REVISION TRANSMITTAL

This sheet transmits Revision 2 to SB700-25-02 which:

EQUIPMENT/FURNISHINGS - FORWARD DIVIDER DOOR/GARMIN INTERFACE

SB700-25-02
Page 1 of 6

Figure 1. Divider Door/Garmin Interface Wiring Modification (Sheet 1)

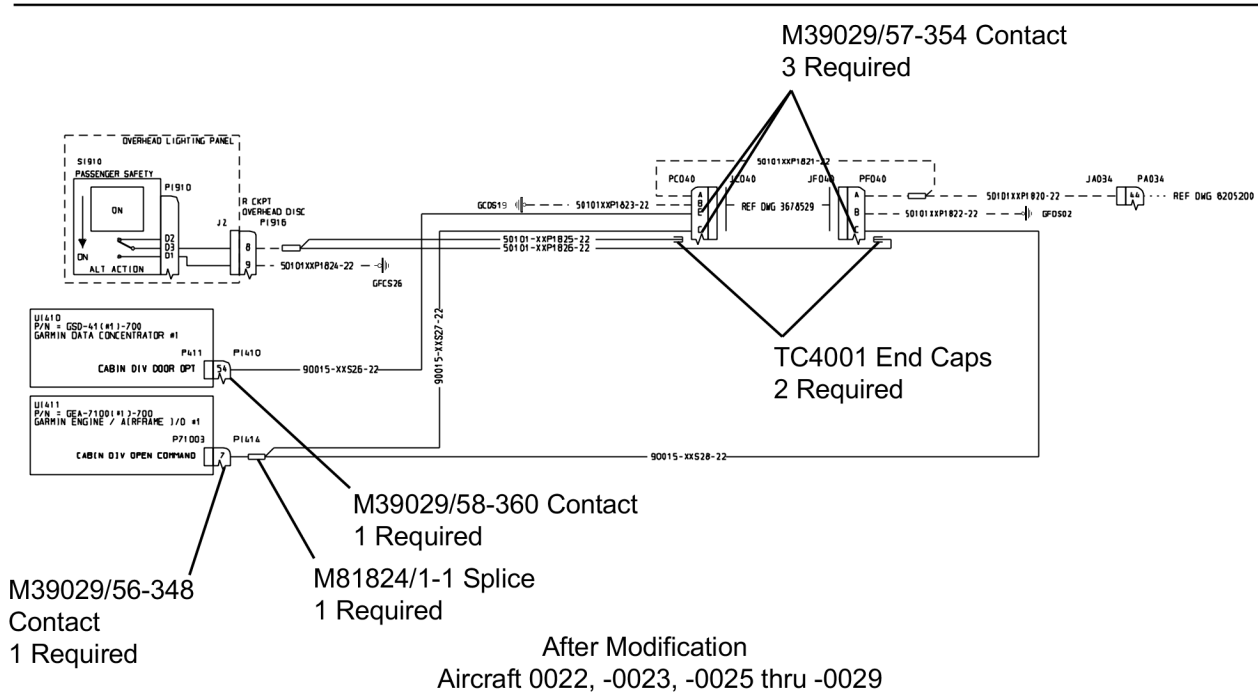
2. (Refer to Figure 1, Sheet 1.) Aircraft -0022, 0023 thru -0029, do the wiring modification per wire diagram.
 - A. After wiring modification is complete, Using an indelible marker, identify circuit breaker HZ233 located on the right DC power junction box circuit breaker placard as 'FWD DIVIDER'.

Before Modification
 Aircraft -0022, -0023, -0025 thru -0029

After Modification
 Aircraft 0022, -0023, -0025 thru -0029

Figure 1. Divider Door/Garmin Interface Wiring Modification (Sheet 2)

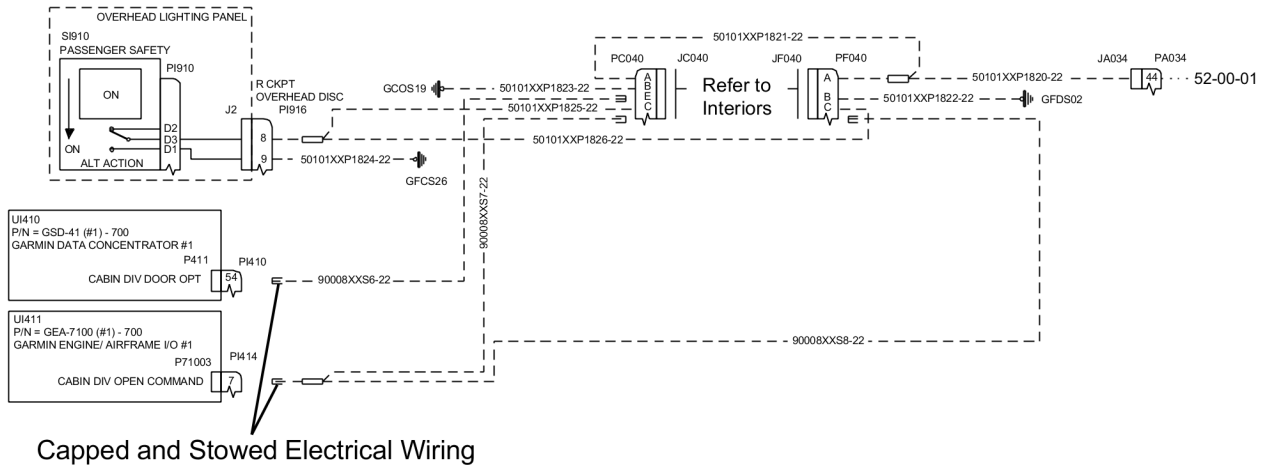
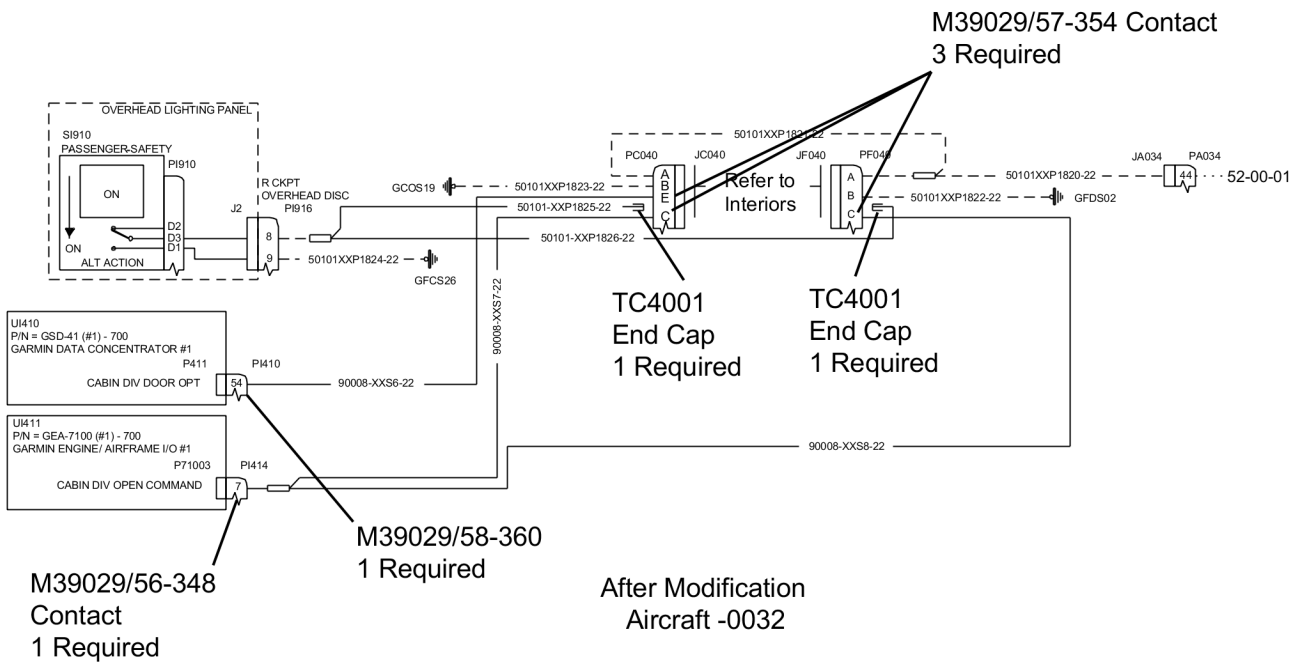
3. (Refer to Figure 1, Sheet 2.) Aircraft -0032 do the wiring modification per wiring diagram.
 - A. After wiring modification is complete, Using an indelible marker, identify circuit breaker HZ233 located on the right DC power junction box circuit breaker placard as 'FWD DIVIDER'.

Before Modification
 Aircraft -0032
